Product Change Notification / KSRA-18BGHS695

CCB 4559 Final Notice: Qualification of SIGN as a new assembly site for selected SST39LFxxxx and SST39VFxxxx device families available in 48L TSOP (12x20mm) package.

CCB 4559
Pre and Post Change Summary
PCN # KSRA-18BGHS695

Lead frame Comparison

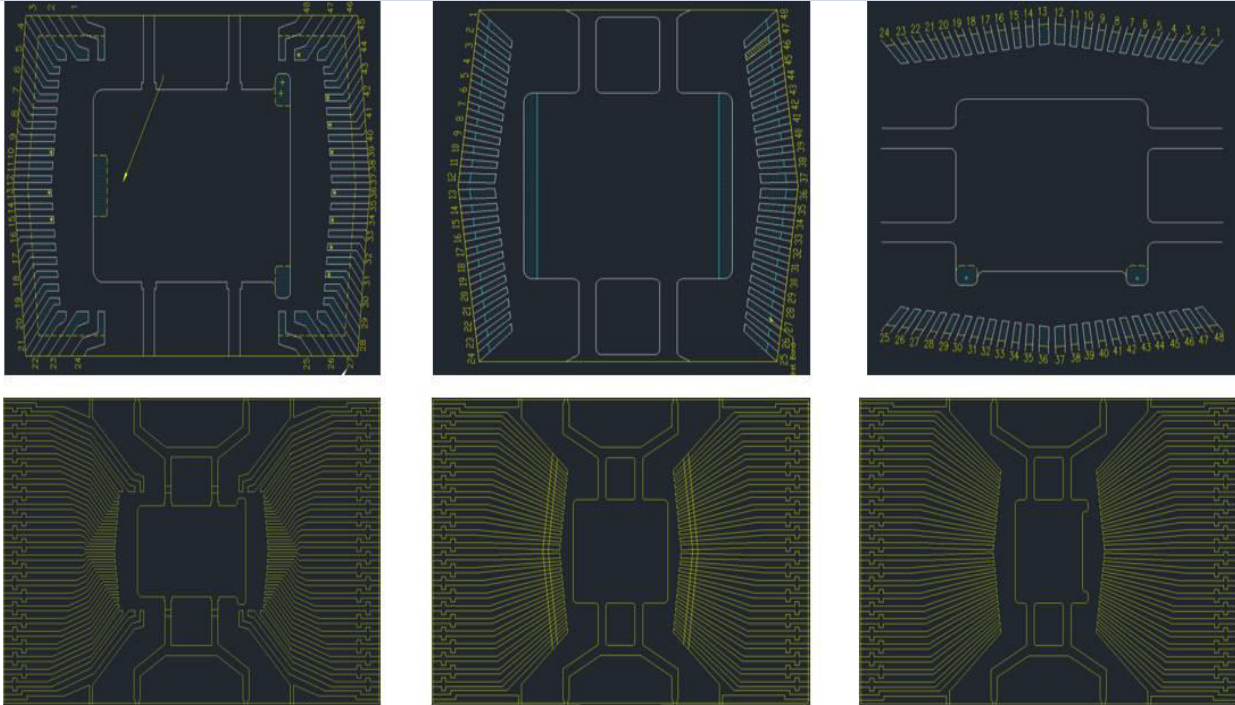
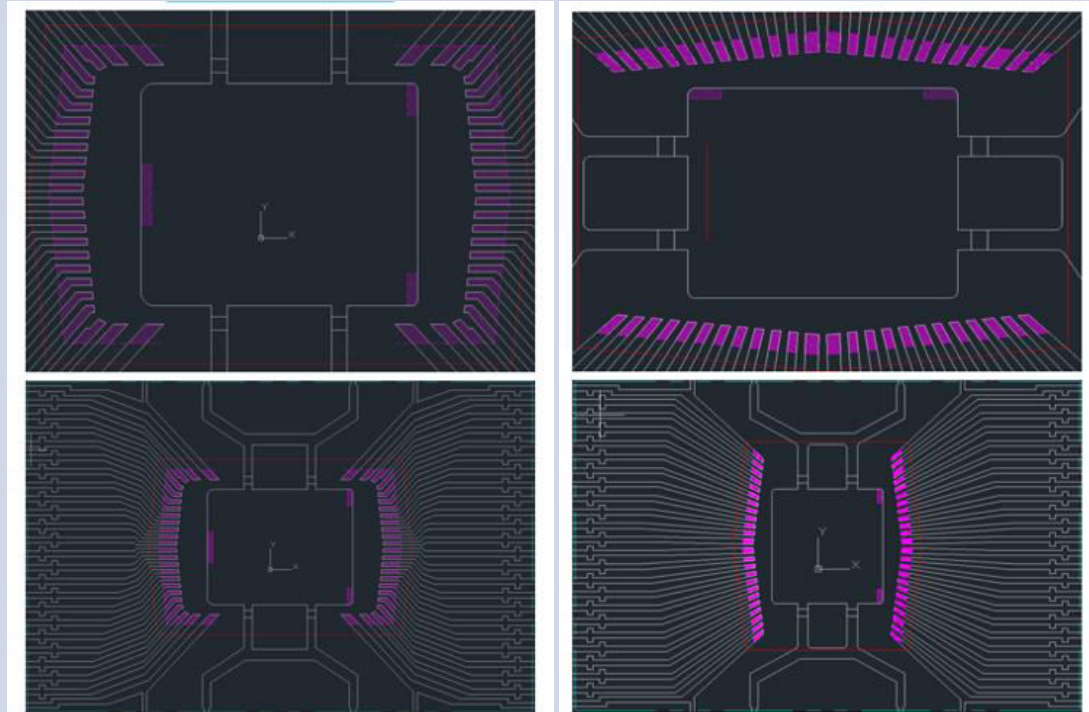
Assembled at LPI using 8340 die attach material and lead frame with paddle size 207x142mils, 183x161mils or 160x130mils.

Assembled at SIGN using AP-4300 die attach material and lead frame with paddle size 209x165mils or 159x165mils
